RIVERPARK II

STORM SEWER PLAN & PROFILES
 GENERAL CONTRACTOR - UTILITY CONTRACTORS INC.
 1977 U-1065

City of Wichita Private Storm Sewer NO. DBKW 707043

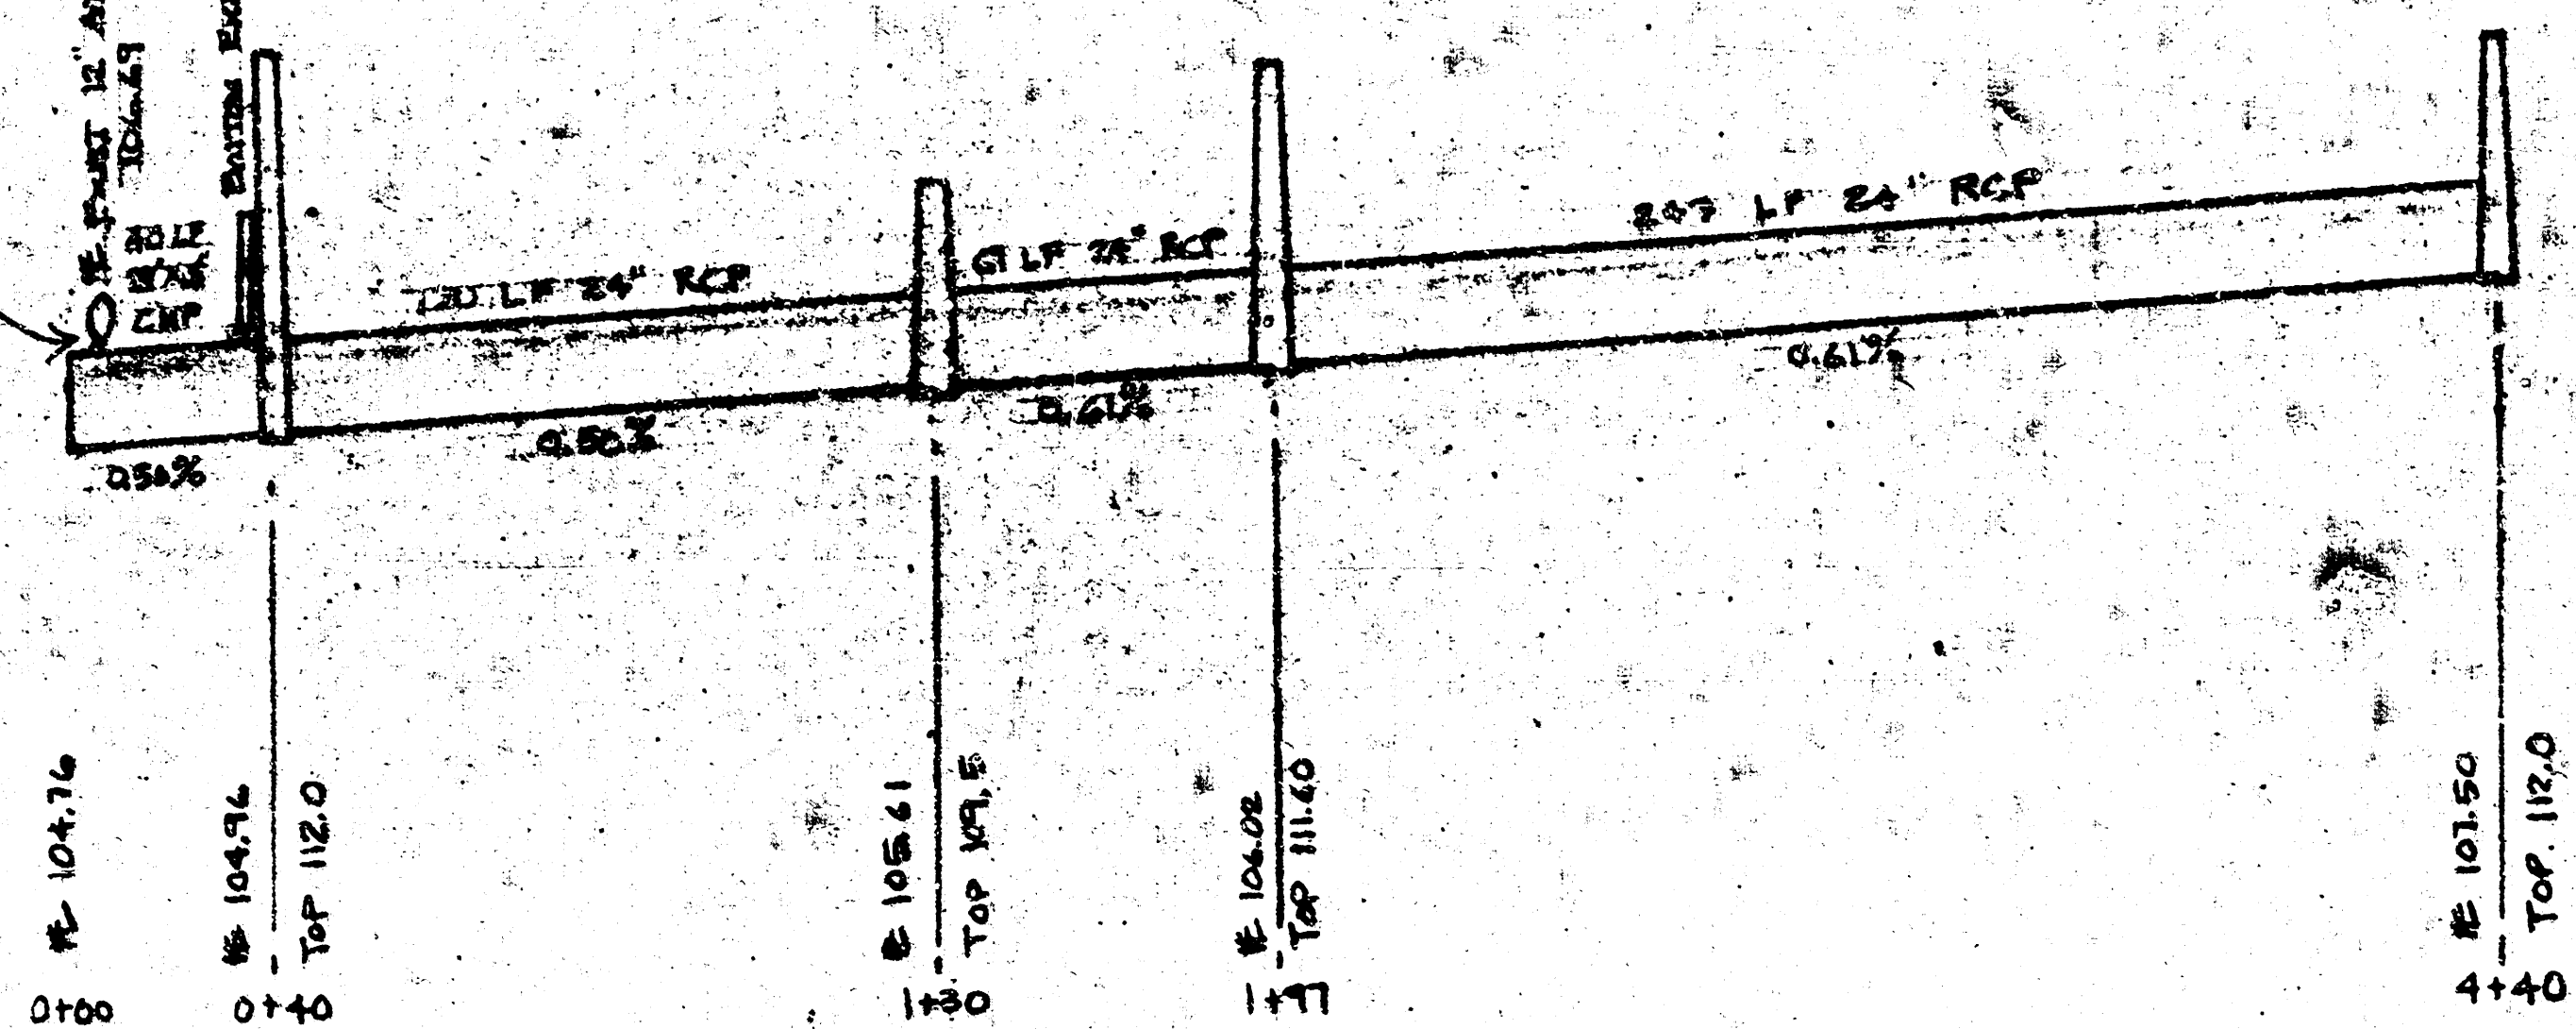
2' or 3" thick minimum
Gone. Cradle around water pipe
required. *Yes*
